REMARKS

TITLE: SUBSTRATE WITH CONTACT
 ARRAY AND SUBSTRATE ASSEMBLIES
 Inventor: Robert L. Canella
 Serial No.: 09/941,853
 Docket No.: 2269-4322US

FIG. 4

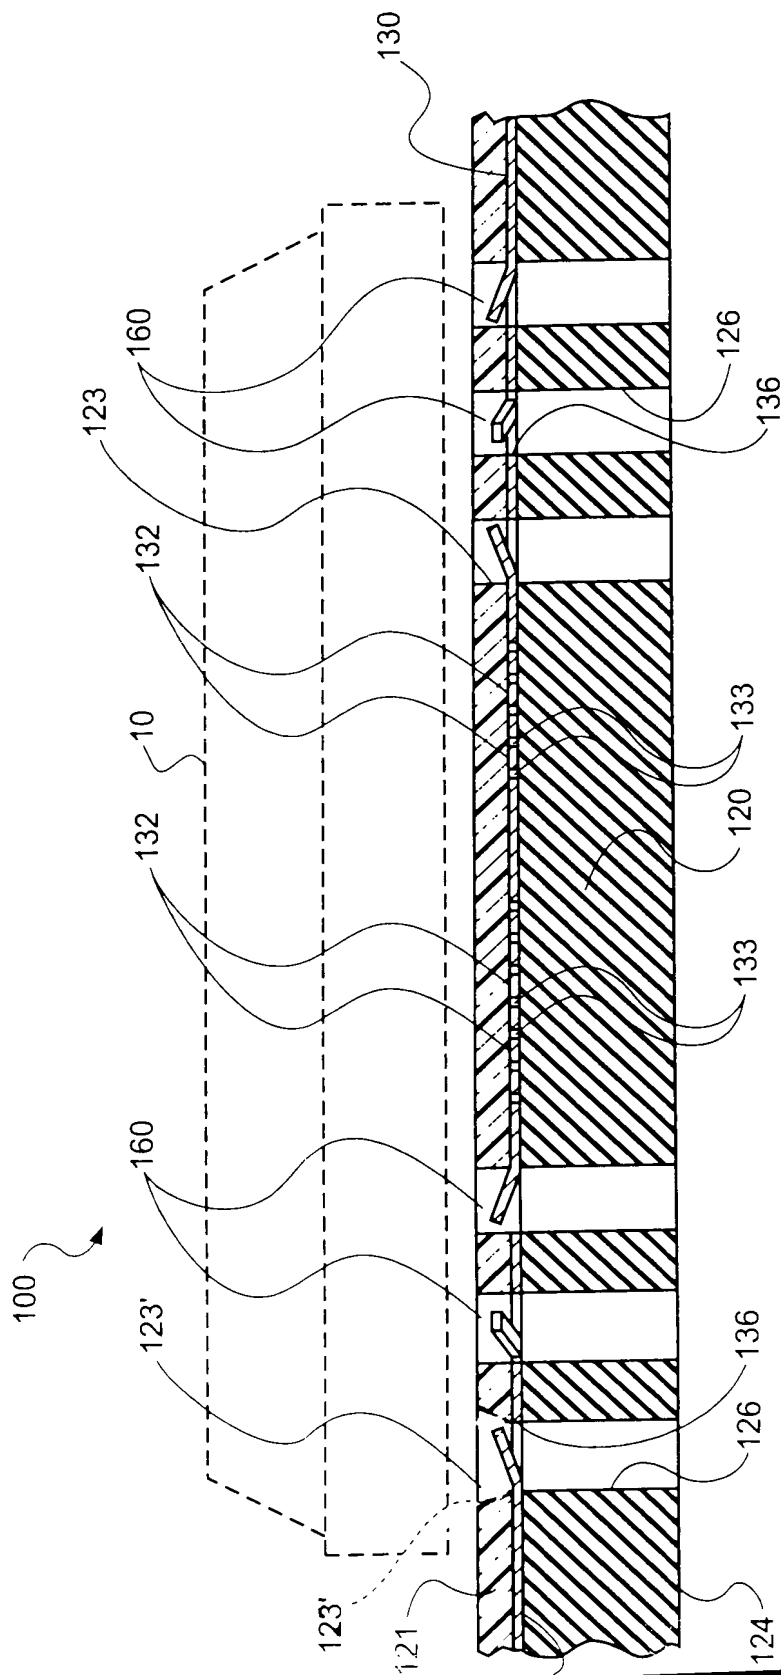
The drawings stand objected to under 37 CFR 1.83(a), in that they "must show every feature of the invention specified in the claims." The Examiner has objected to the drawings because "the aperture of a frustoconical configuration decreasing in size towards the sheet of resilient material must be shown." (Office Action mailed June 4, 2003, at Page 2, ¶ 2.) Applicant respectfully submits that the aperture of frustoconical configuration decreasing in size towards the sheet of resilient conductive material is shown in the original FIG. 4 by broken lines 123' and is described in the as-filed specification at paragraph [0044]. Accordingly, Applicant submits that the drawings presently show every feature of the invention specified in the claims.

Nevertheless, Applicant submits herewith drawing corrections intended to eliminate any confusion regarding the frustoconical configuration of the claimed aperture. Specifically, Applicant has amended FIG. 4 to more clearly depict aperture 123' in solid cross-section. The attached replacement drawing, which includes changes to FIG. 4, replaces the previous drawing sheet submitted for FIG. 4. An annotated sheet showing changes marked in red is also attached.

Applicant respectfully submits that claims 46, 49, 52, and 55 are presently supported by the as-filed specification and particularly point out and distinctly claim the subject matter which Applicant regards as the invention. As discussed above, however, Applicant has amended FIG. 4 of the drawings to more clearly depict aperture 123' in solid cross-section. Applicant has also amended paragraph [0044] of the specification to reflect the changes made to FIG. 4.
